### APPEAL SUMMARY

<b>Appeal ID:</b> 15364	<b>Project Address:</b> 6012 SE Yamhill St
<b>Hearing Date:</b> 7/12/17	<b>Appellant Name:</b> David Rodeback
<b>Case No.:</b> B-021	<b>Appellant Phone:</b> 5035025490
<b>Appeal Type:</b> Building	<b>Plans Examiner/Inspector:</b> Steven Freeh
<b>Project Type:</b> commercial	<b>Stories:</b> 4 <b>Occupancy:</b> R-2 <b>Construction Type:</b> V-A
<b>Building/Business Name:</b>	<b>Fire Sprinklers:</b> Yes - Throughout
<b>Appeal Involves:</b> Alteration of an existing structure, Reconsideration of appeal, occ Change from R-1 to R-2	<b>LUR or Permit Application No.:</b> 17-168858-CO
<b>Plan Submitted Option:</b> pdf [File 1] [File 2] [File 3] [File 4] <b>Proposed use:</b> Apartment 4]

PROPOSED IMPROVEMENTS AT THE:  
PROJECT #: 1412

**6012 SE YAMHILL APARTMENT BUILDING**

**Figure 1**  
**The Proposed Floor/Ceiling Assembly**

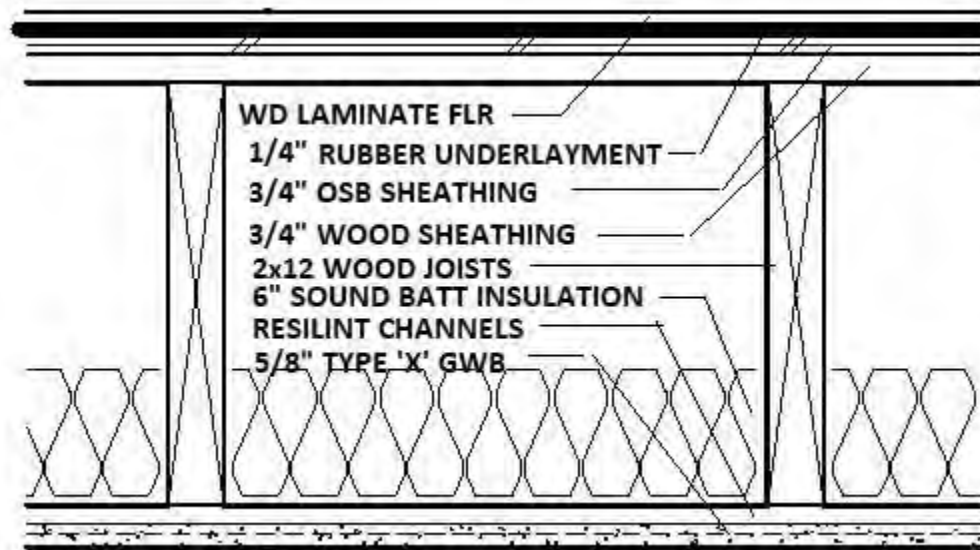
Reconsideration Text:  
New laminate flooring & sound pad over structural sheathing and new gypsum board & resilient channels are proposed with the existing wood joists & sheathing. The GA File No FC 5120 listing addresses carpet & pad but not laminate flooring & pad. The proposed assembly in the attached letter by 'A Acoustics' has an STC of 52 and an IIC of 55. Also see building sections A2.1

At the request of *David Rodeback*, AAcoustics provides a design for upgrading an existing floor/ceiling assemblies in the apartment building on 6012 SE Yamhill Street Portland, Oregon 97215. The design floor/ceiling assembly will have an STC of 52, and IIC of 55.

- New, Wood Flooring Laminates
- New, 1/4" (6 mm) Rubber Underlayment
- New, 3/4" thick Oriented Strand Board Sheathing
- Existing 3/4" Thick Diagonal Floor Sheathing
- Existing 2X12 @ 16 OC Wood Floor joists
- New 6" thick insulation in the cavity between the joists
- New 1/2" Resilient channels 16" OC
- New 5/8" thick Gypsum Board Ceiling

The gaps in the Diagonal Floor Sheathing must be filled before the layouts of the Oriented Strand Board Sheathing above it. Remove the existing lath and plaster ceiling, add 6" thick insulation in the cavity between the floor joists and Install resilient cannels at right angles to the joists. When attaching the gypsum board to the resilient channels, never screw through the resilient channel into the floor joists.

This Proposed Floor/Ceiling Assembly shown in Figure 1 Shall have STC rating and IIC ratings above STC-50 and IIC-50. Therefore, the proposed Floor/Ceiling Assembly comply with the Section 1207 in Chapter 12 of the 2010 Oregon Structural Specialty Code.

**GA FILE NO. FC 5120****GENERIC****1 HOUR  
FIRE****50 to 54 STC  
SOUND****WOOD JOISTS, GYPSUM WALLBOARD, RESILIENT CHANNELS, GLASS FIBER INSULATION**

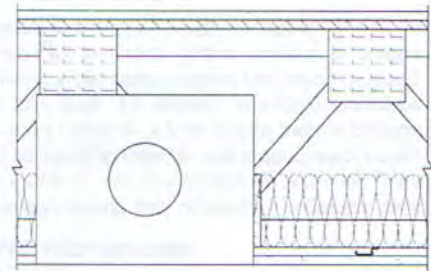
Reconsideration Text:  
This existing partition can be considered 1/2 hour and is only 5' in length with most of the area consisting of a rated door. See attached sheet A1.6, door D16, just NW of the elevator.  
The existing floor/ceiling assembly after retrofitting will have a 1-hr rating per GA File No FC 5120

**A1.6**

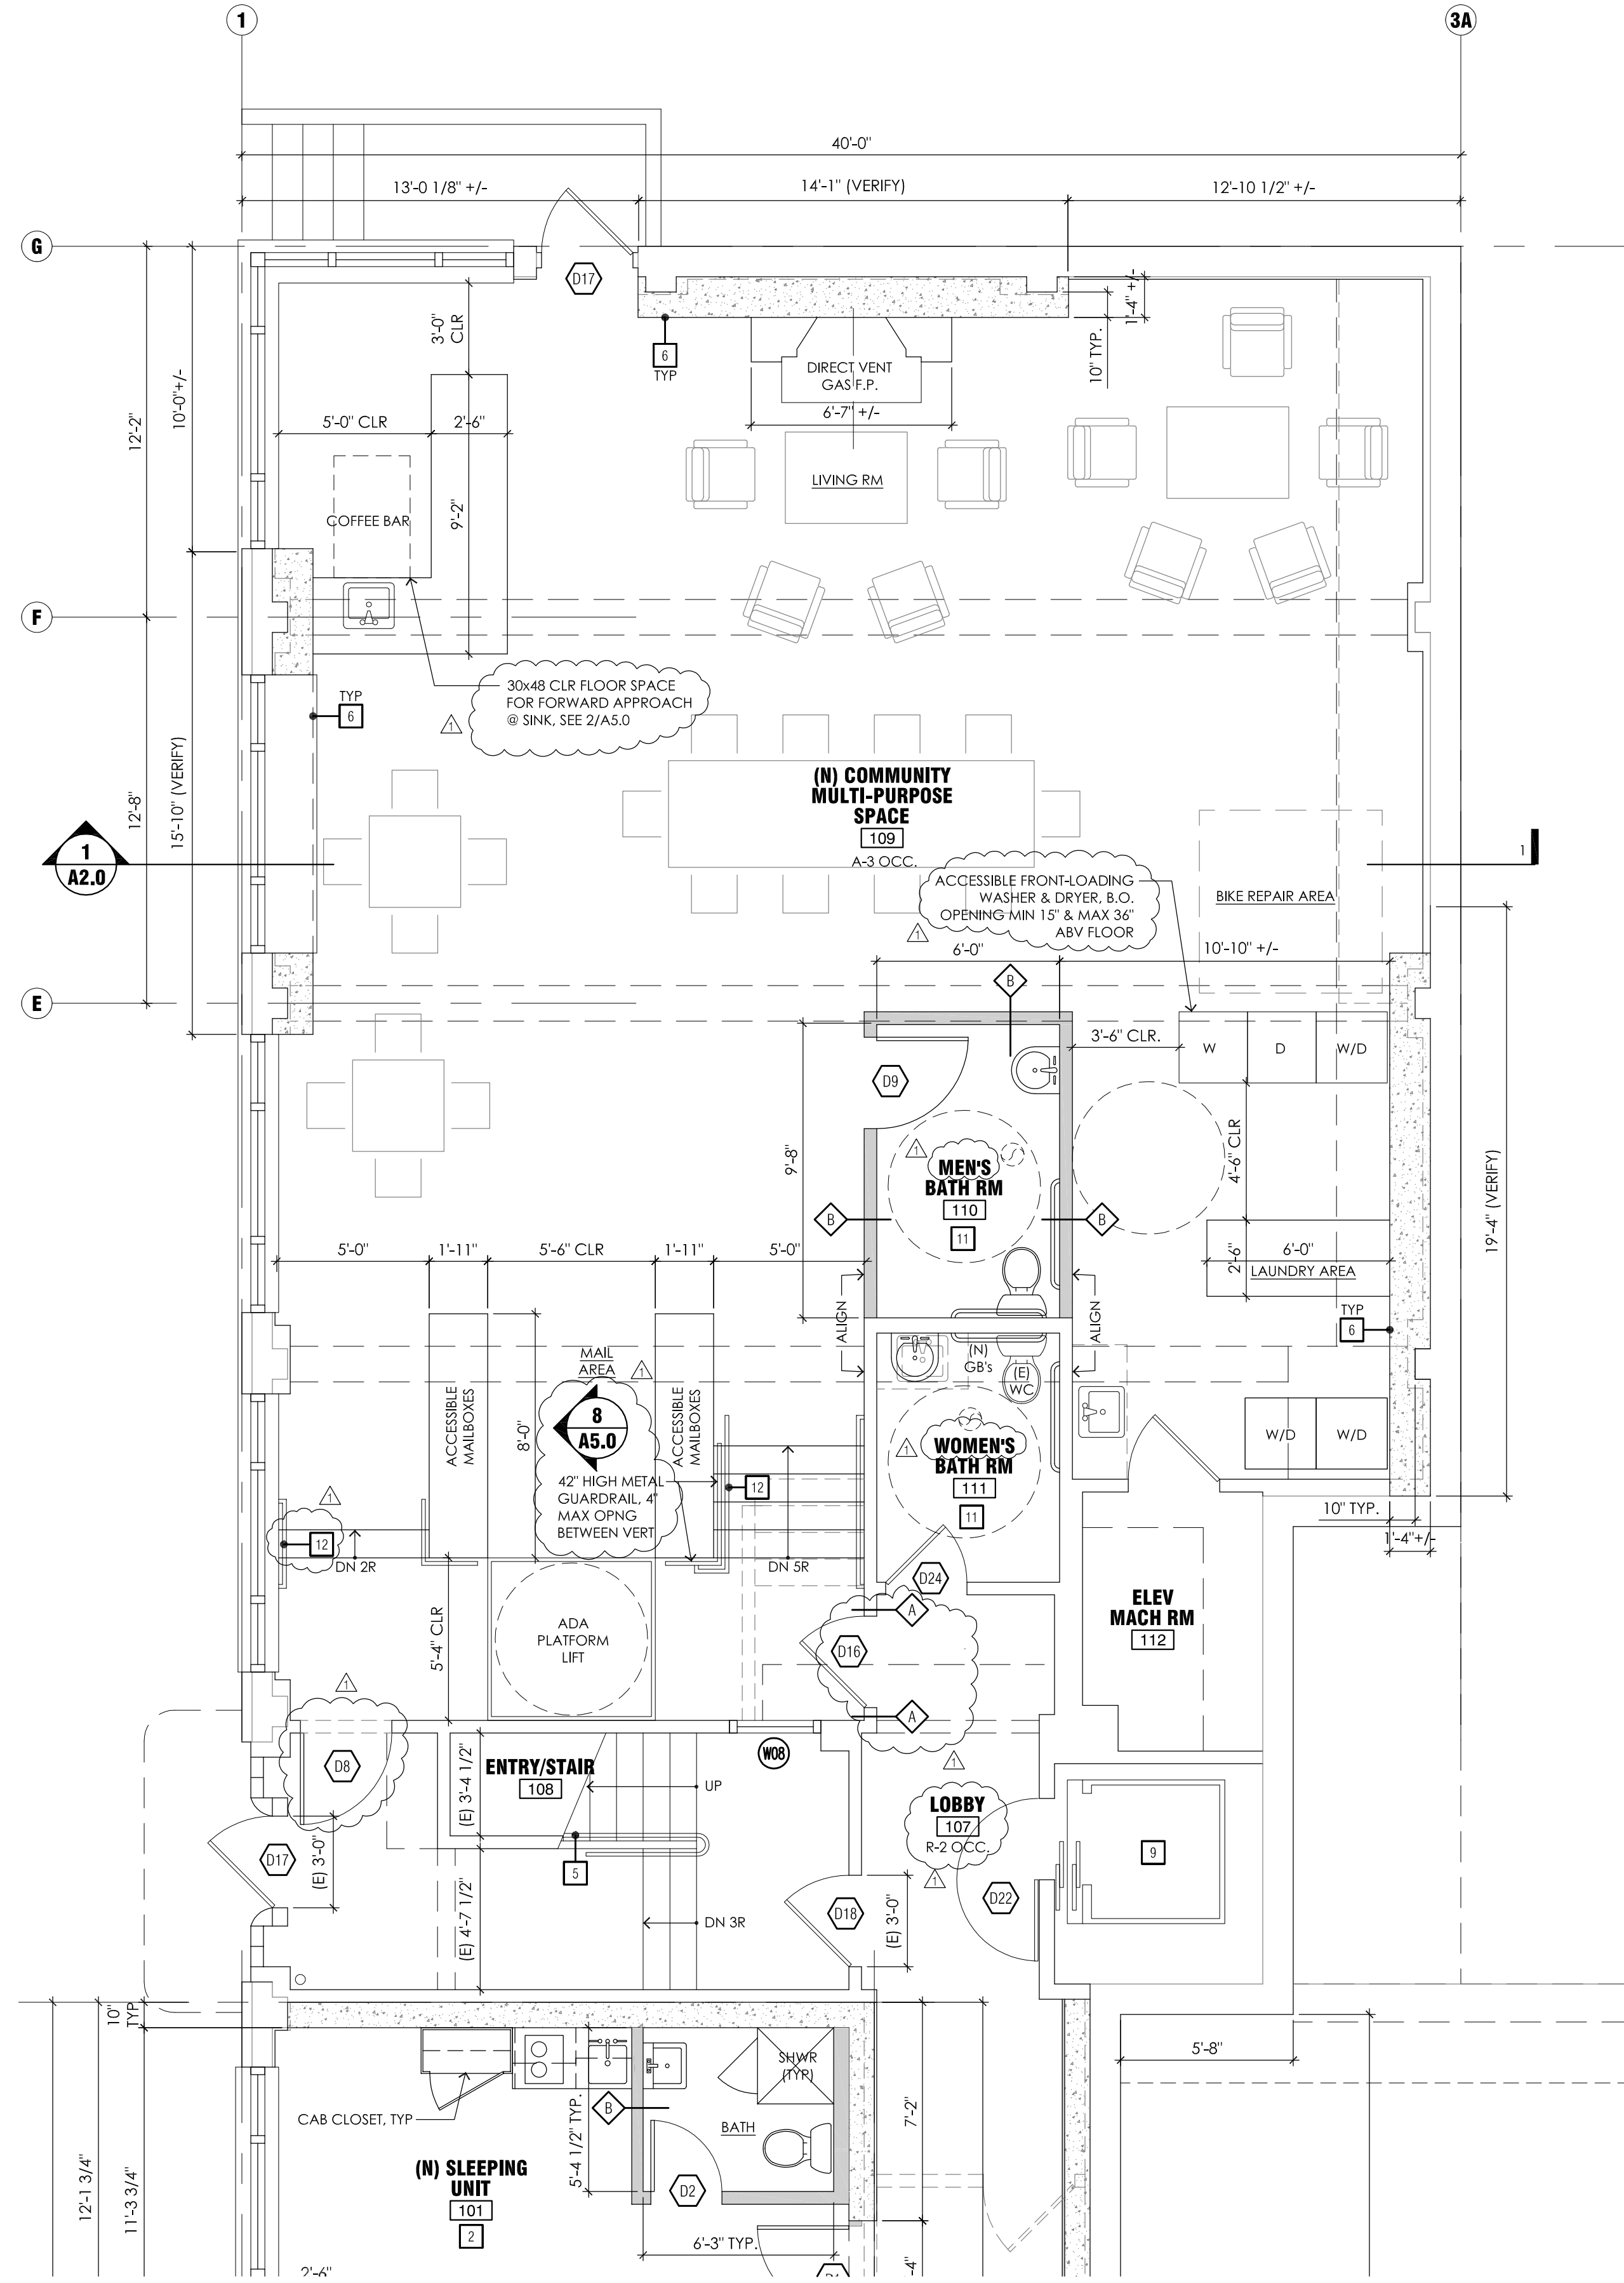
**Appeal Item 3**
